TENDER ADDENDUM

**NCC – RESIDENCE FRONT ENTRANCE
REHABILITATION**
NCC tender file # LW031
June 13, 2016
ADDENDUM NO : 4

drawing
dessin
**ELECTRICAL POWER AND SYSTEMS
DEMOLITION AND NEW WORK
BASEMENT LEVEL**

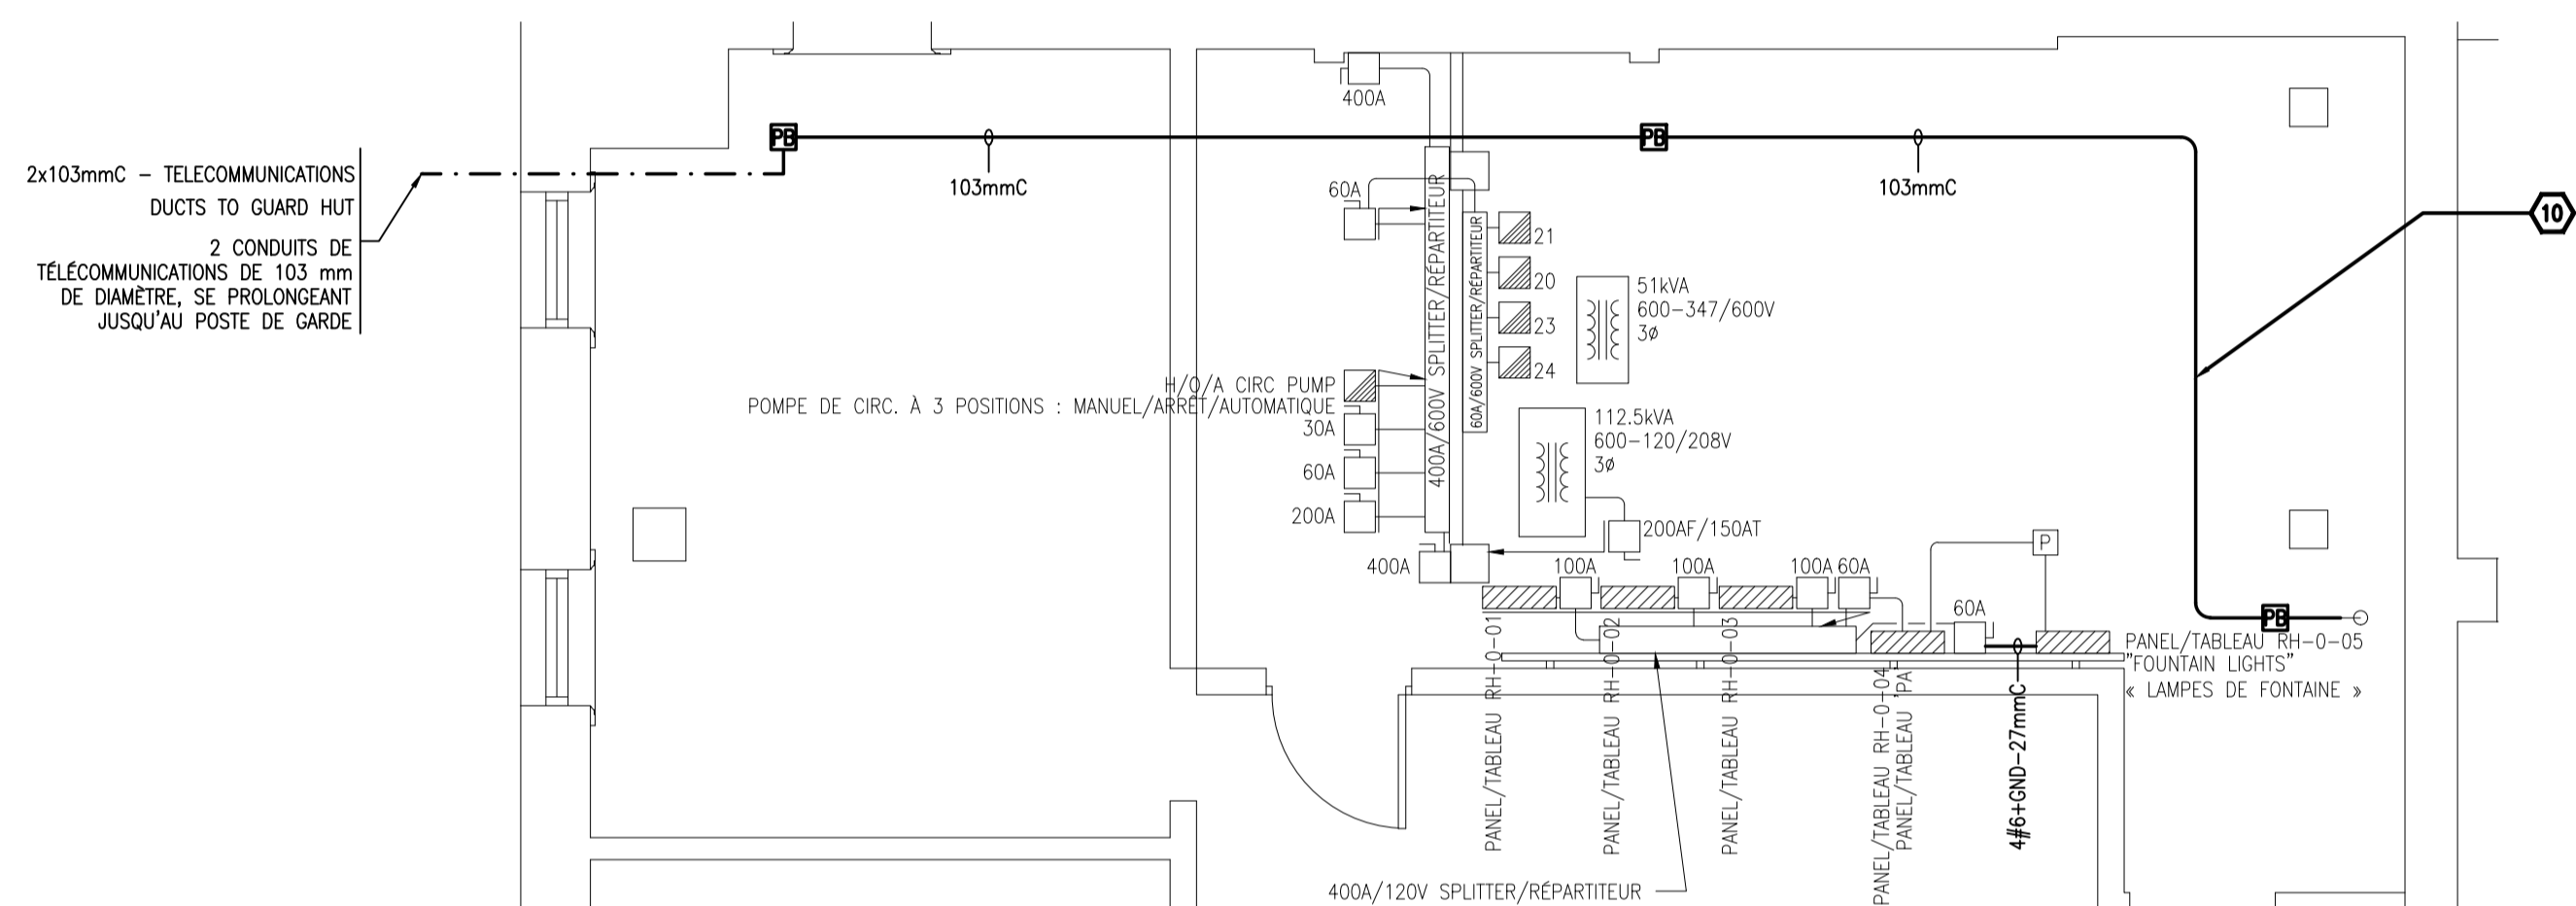
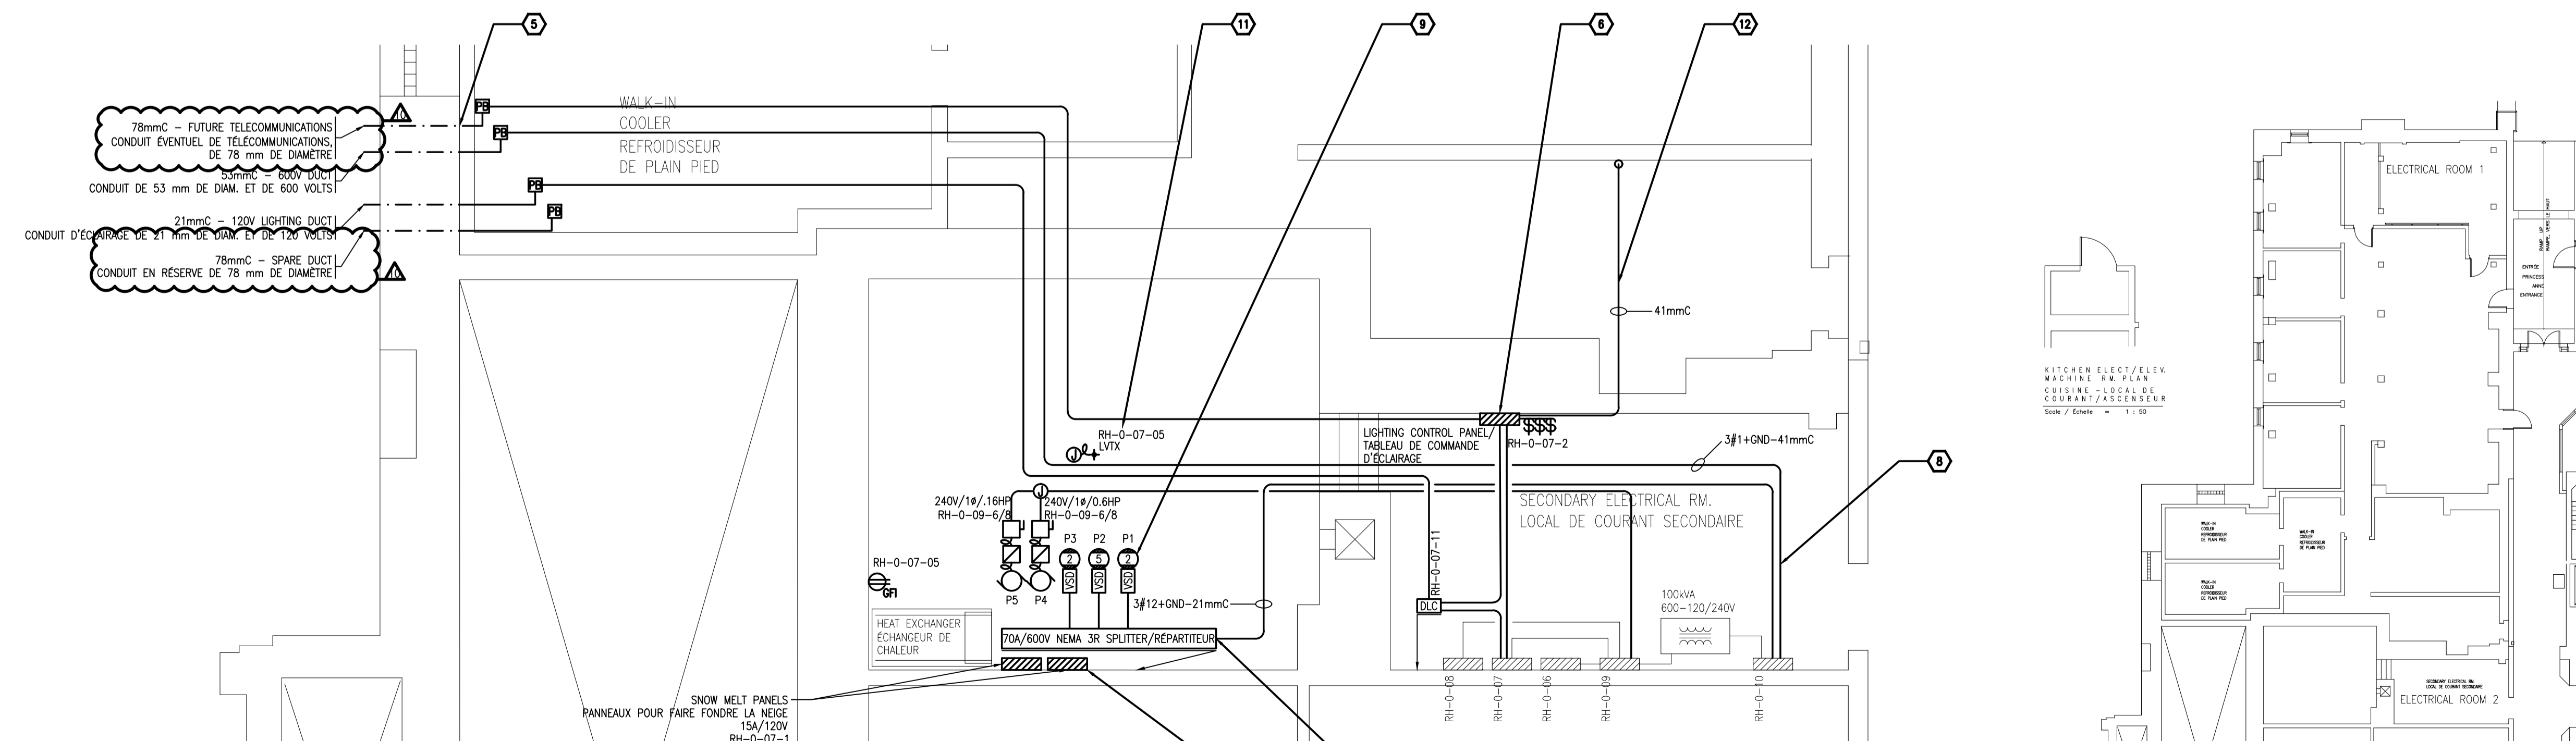
- 10 PROVIDE NEW CONDUIT FOR USE BY EXTERNAL CONTRACTOR(S) FROM EXISTING TELECOMMUNICATIONS CONDUIT STUB DOWN FROM LEVEL 02, TO CONDUIT PENETRATIONS THROUGH EXTERIOR TO GUARD HUT. REFER TO DRAWING E8 FOR EXTERIOR CONDUIT DETAILS.

A8: The BAS contractor is to make use of the "future telecommunications" conduit for their low voltage wiring. Refer to addendum #4.

drawing
dessin
**ELECTRICAL POWER AND SYSTEMS
DEMOLITION AND NEW WORK
BELOW FOUNTAIN**

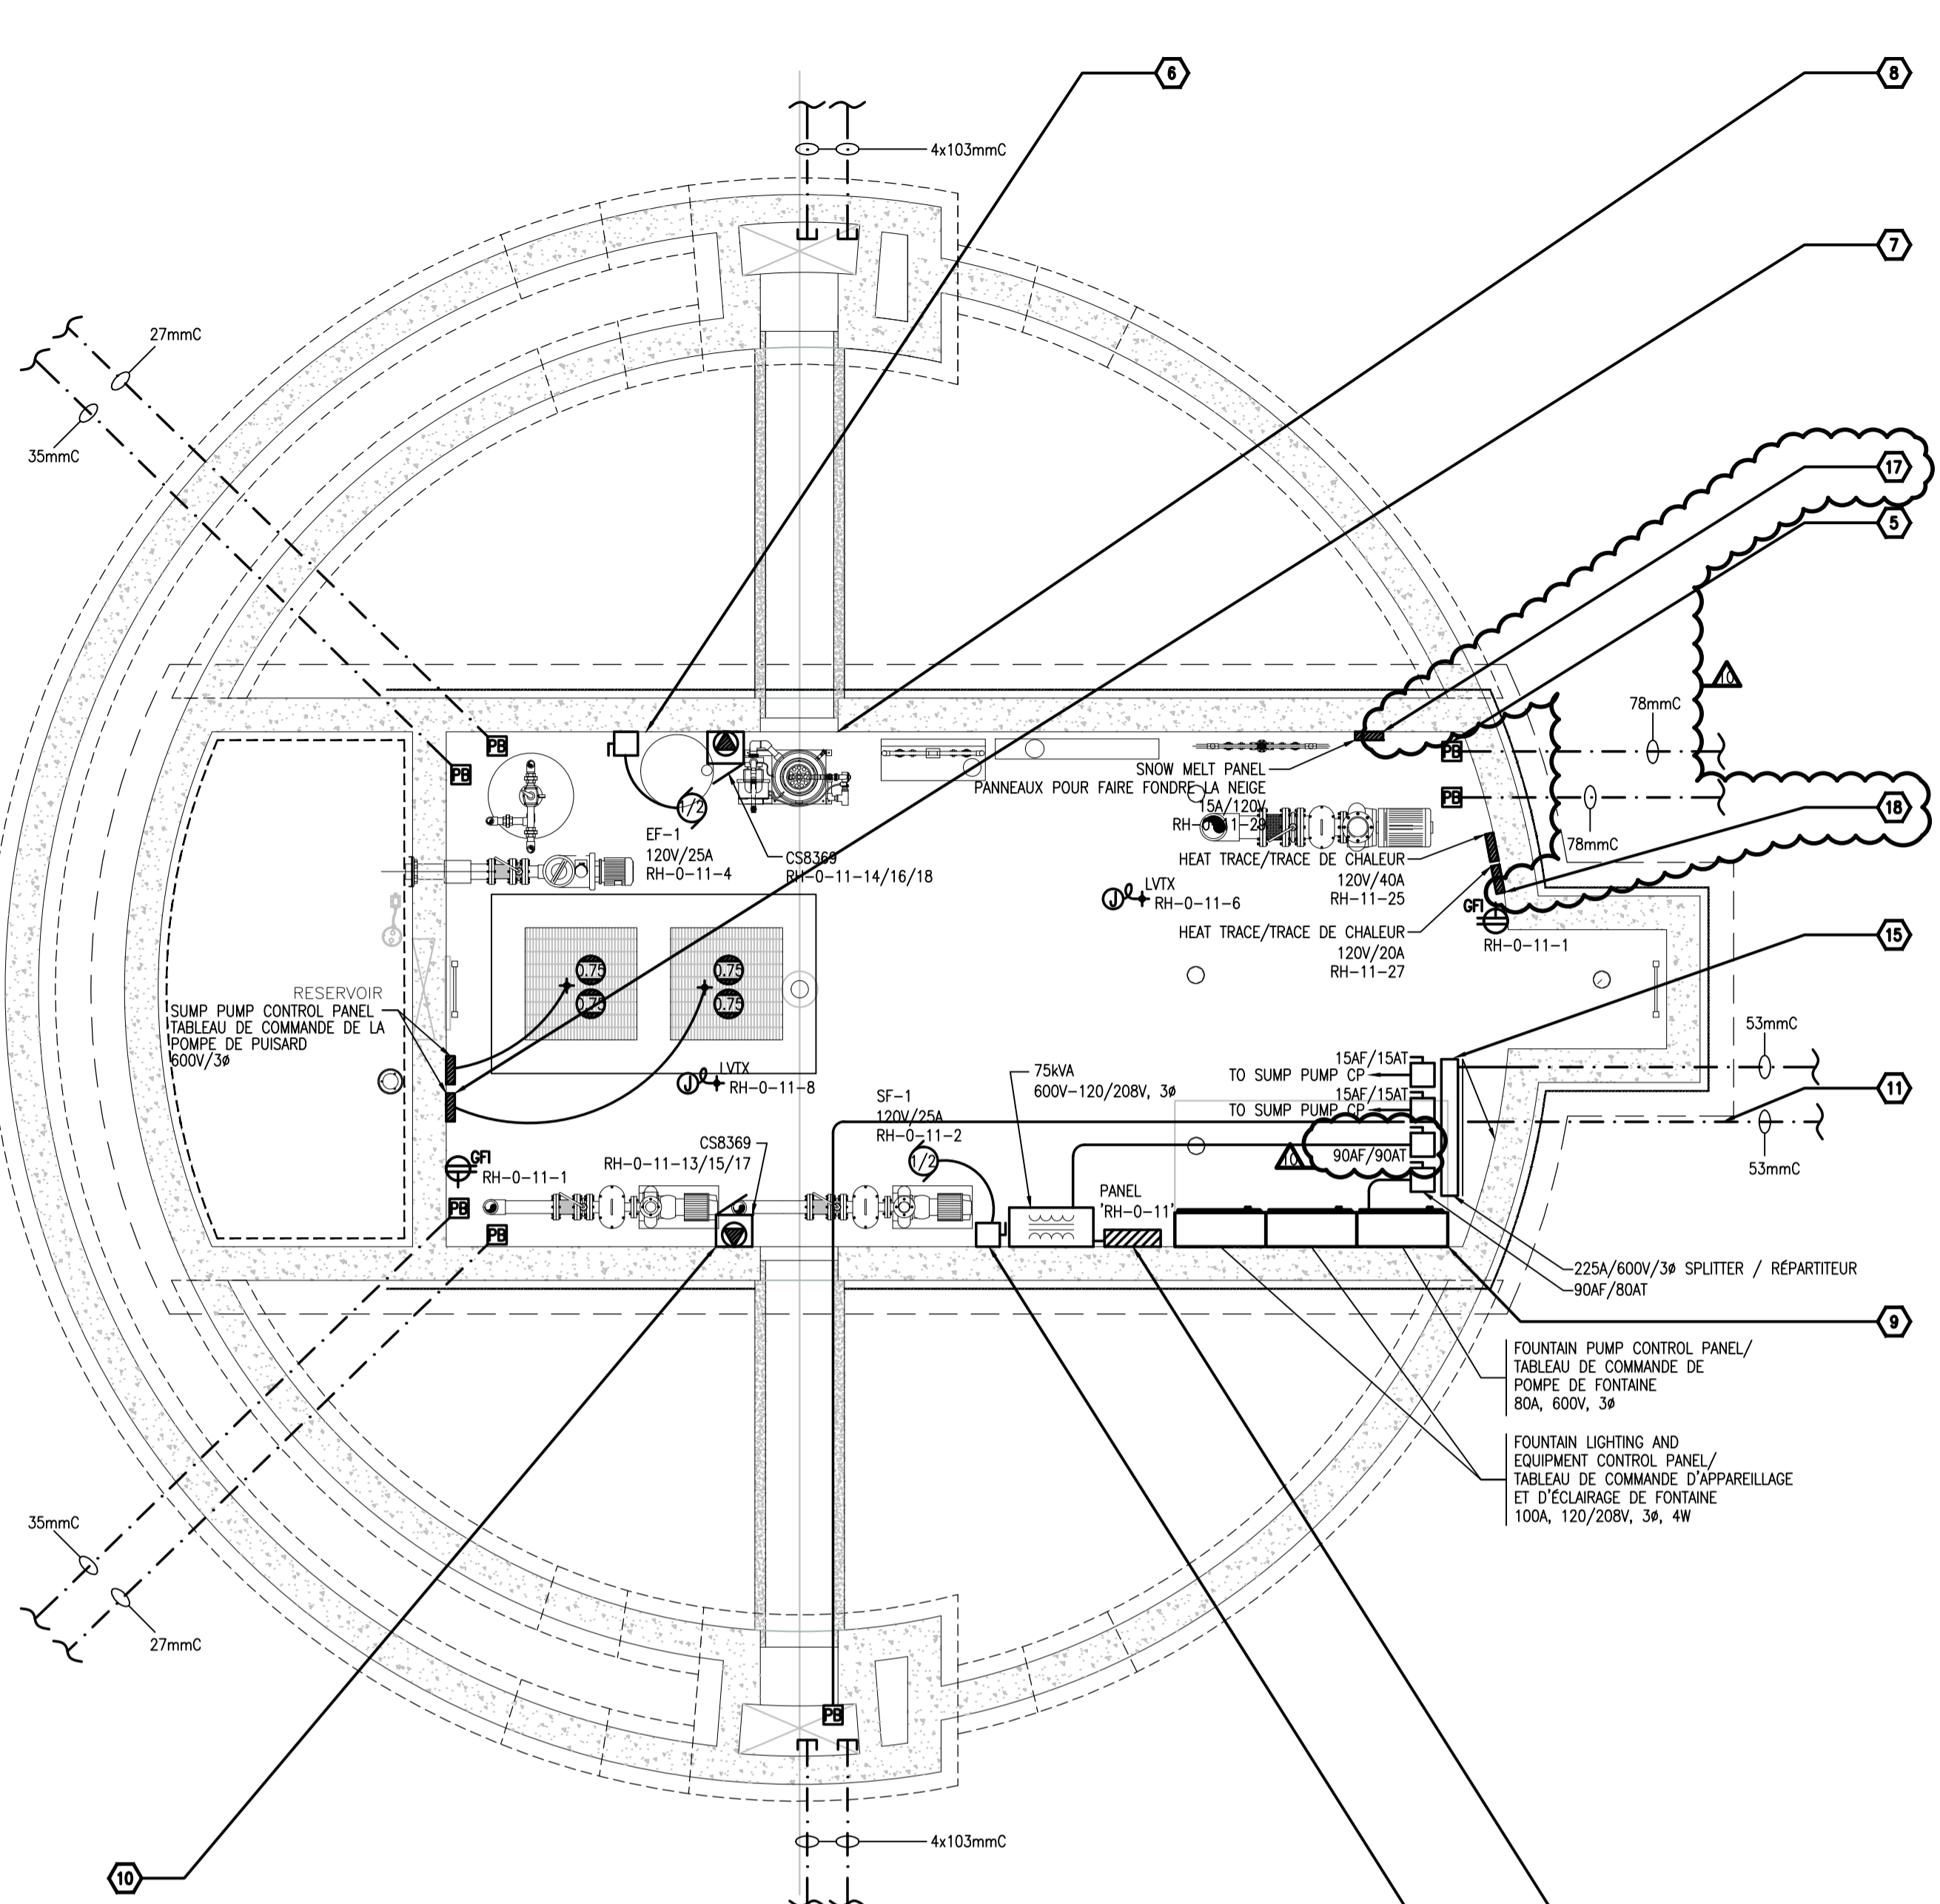
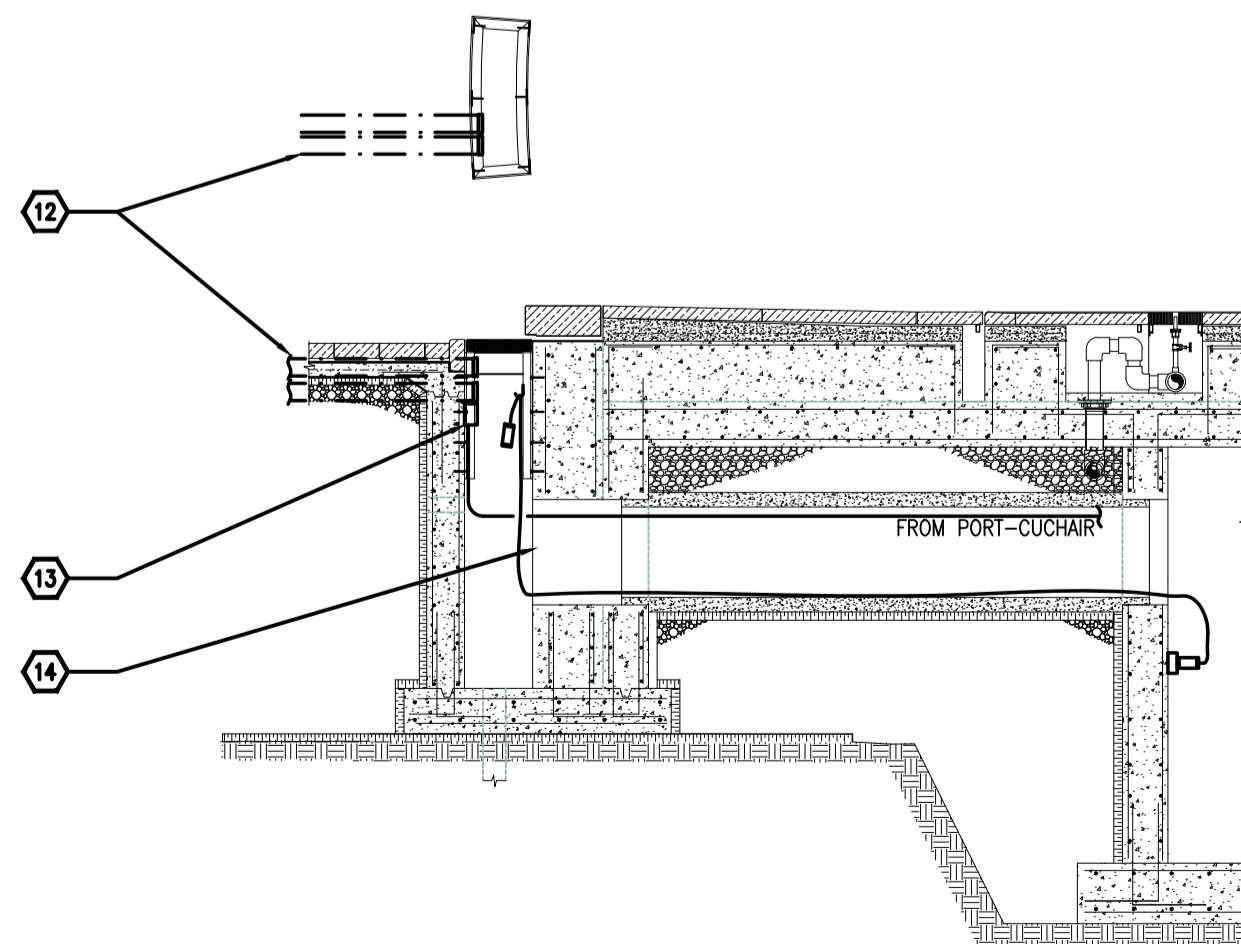
- E5: Replace with rev 10 (Addendum E-3), 06-06-2016:
 - Revise fuse size from 80A/600V to 90A/600V on 90A/600V disconnect for panel RH-0-11 within fountain pit.
 - Revise panel RH-0-11 from 400A frame to 225A frame rating. Revise main breaker from 200A to 225A.
- E3, E5, and E8: Replace with rev 10 (Addendum E-3), 06-06-2016:
 - Revise “future telecommunications” conduit size to 78mm.
 - Revise “spare duct” conduit size to 78mm.
